RTS-TB-030

25-July-2014

AIO-16 Audio Port Noise Susceptibility

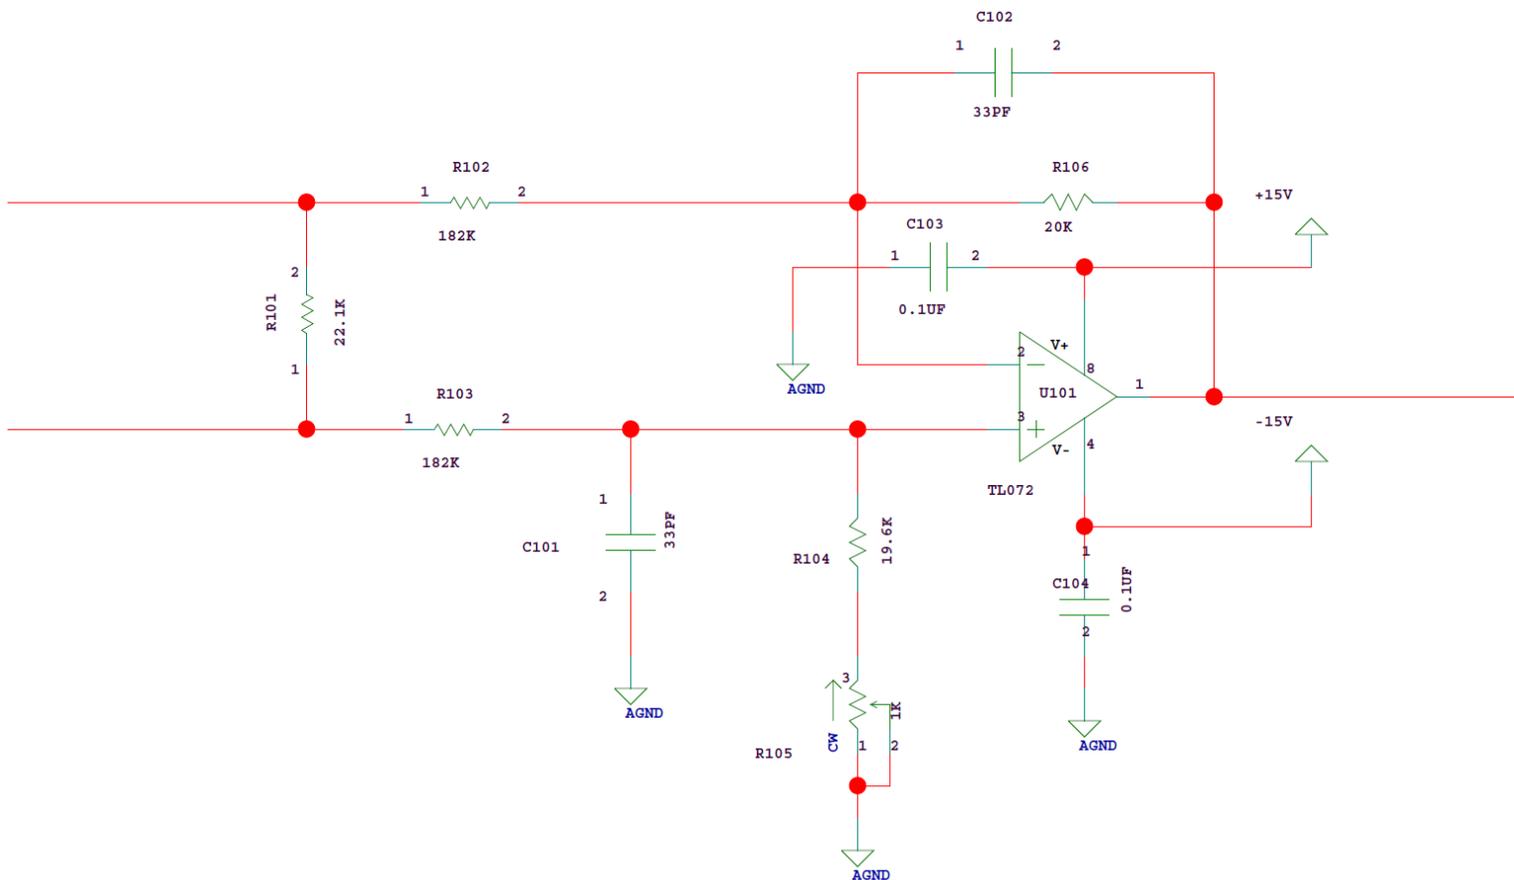
In the schematic below, locate potentiometer R105, 19.6 kOhm resistor R104 and 20 kOhm resistor R106. During the manufacturing process, the potentiometers (R105 in this example) were not properly calibrated. To achieve optimal common mode rejection of noise, the potentiometer R105 must be adjusted so that the sum of $R104 + R105 = R106$ within 40 Ohms.

FIGURE 1: The following assembly print shows a **BOTTOM** view of the AIO-16 Front Card and the location of all eight dual op-amps in the AIO-16 design. Detail A circled in green shows the op-amp U101 associated with the first two channels 1 and 2.

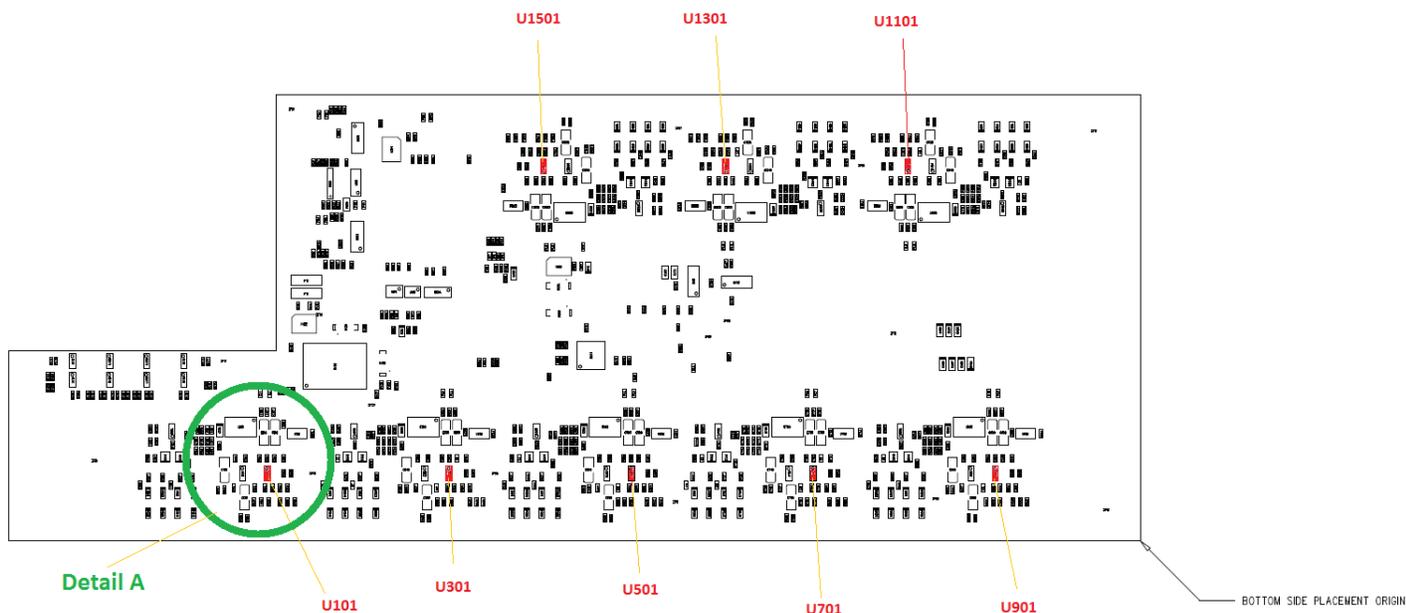
1. Use the op amp locations shown in Figure 1 to locate U101.
2. Figure 2 is a magnification of the area around U101. The circle on U101 in Figure 2 represents the corner corresponding to pin 1.

FIGURE 2: The following drawing shows DETAIL A from the assembly drawing which is a close-up of the circuitry surrounding U101 for channels 1 and 2.

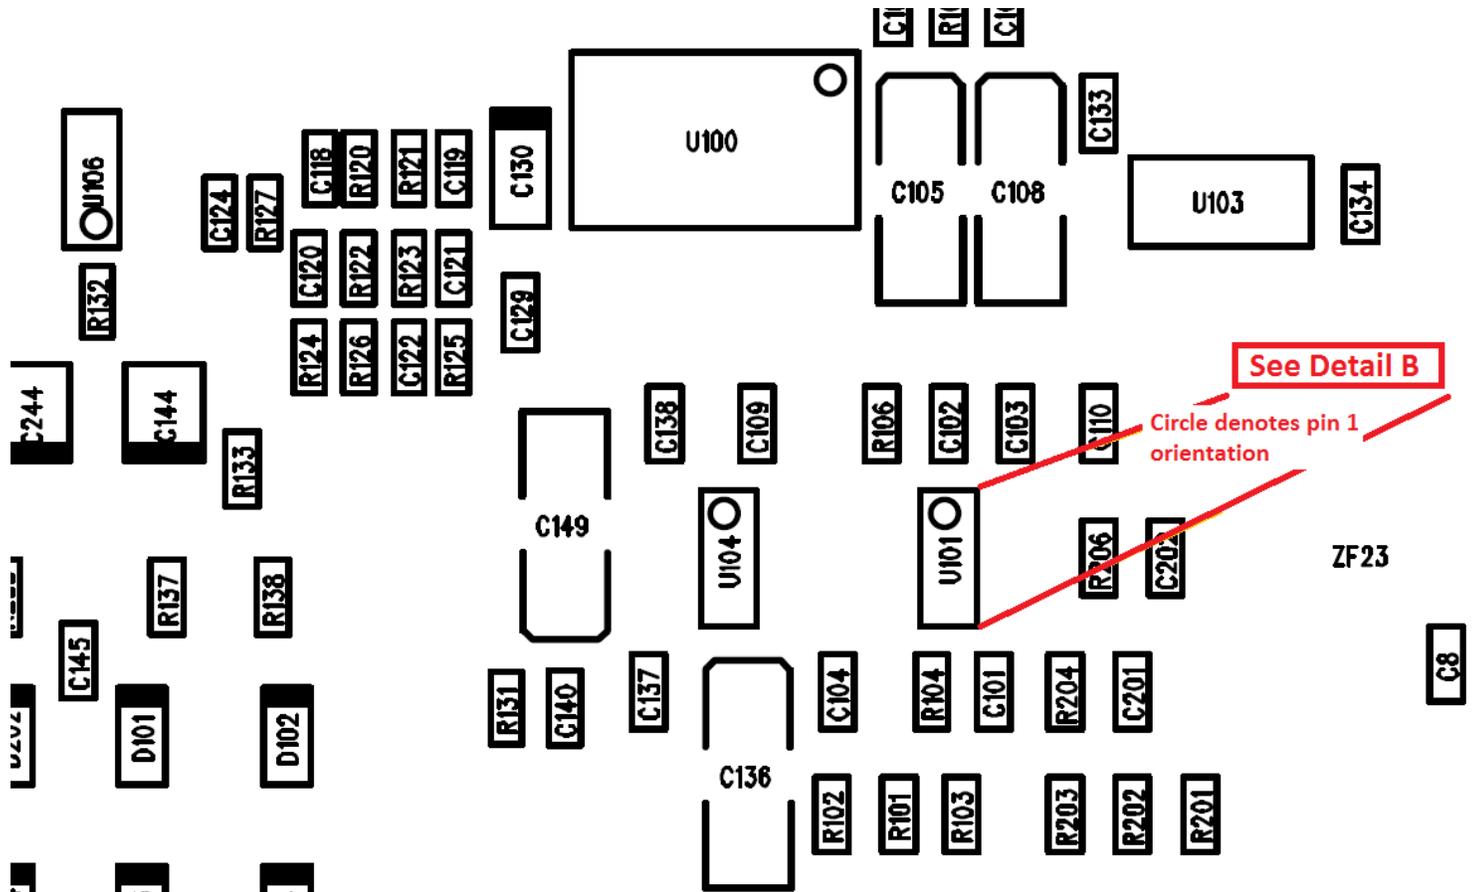
5. Locate R104 on the bottom assembly print Figure 2. It is just below U101.
6. Measure and record the resistance of R104.
7. Subtract the recorded value of R104 from the value of R106. This is the resistance that potentiometer R105 must be adjusted to match.

1. Measure and record the resistance between U101 pin 6 and pin 7. This is the resistance of R206 and should be between 19.00k and 21.00k ohms.
2. Locate R204 on the bottom assembly print Figure 2. It is just below and to the right of U101.

FIGURE 4: This final mark-up of the assembly print represents the **TOPSIDE** view of the AIO-16 Front Card and shows the locations of ALL the potentiometers which need to be adjusted on the AIO-16 card.

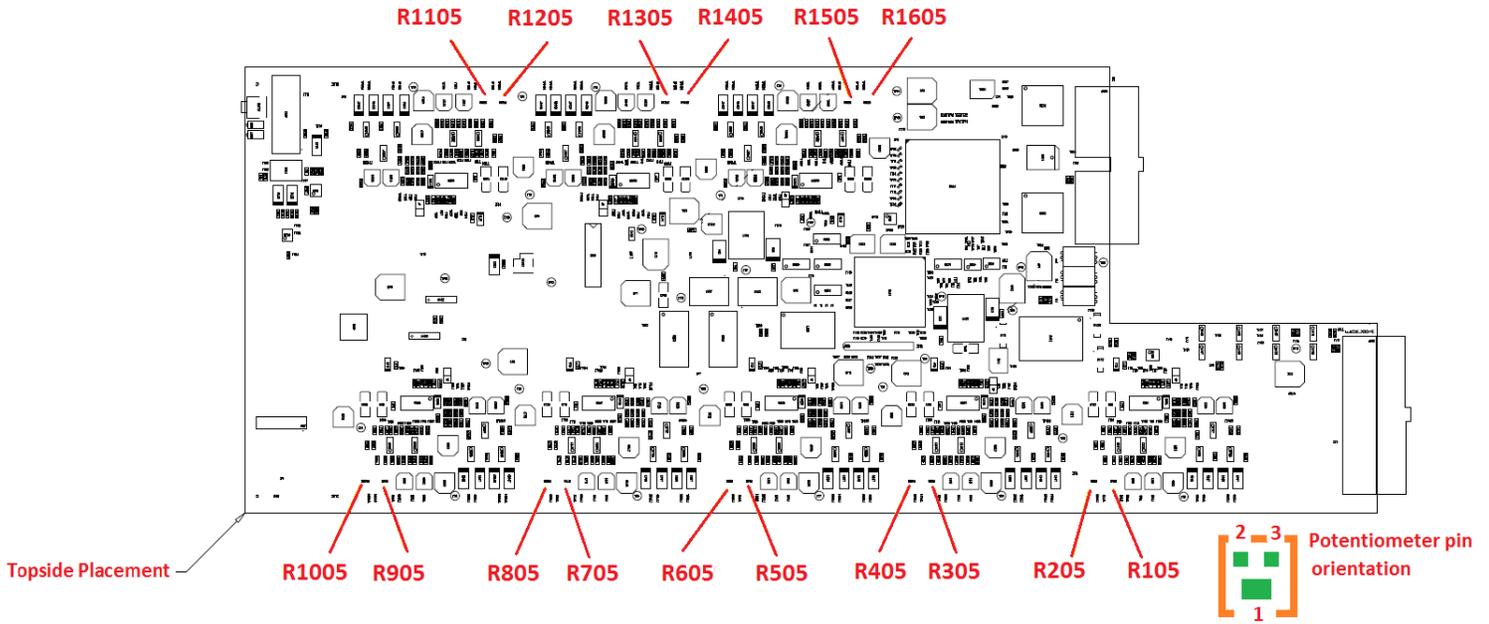
8. Locate R105 on the AIO-16 using Figure 4.
9. Measure the resistance between pin 1 and pin 3 on R105. Use a screwdriver to adjust R105 to the resistance calculated in step 7.

5. Locate R205 on the AIO-16 using Figure 4 (it is next to R105).
6. Measure the resistance between pin 1 and pin 3 on R205. Use a screwdriver to adjust R205 to the resistance calculated in step 4.
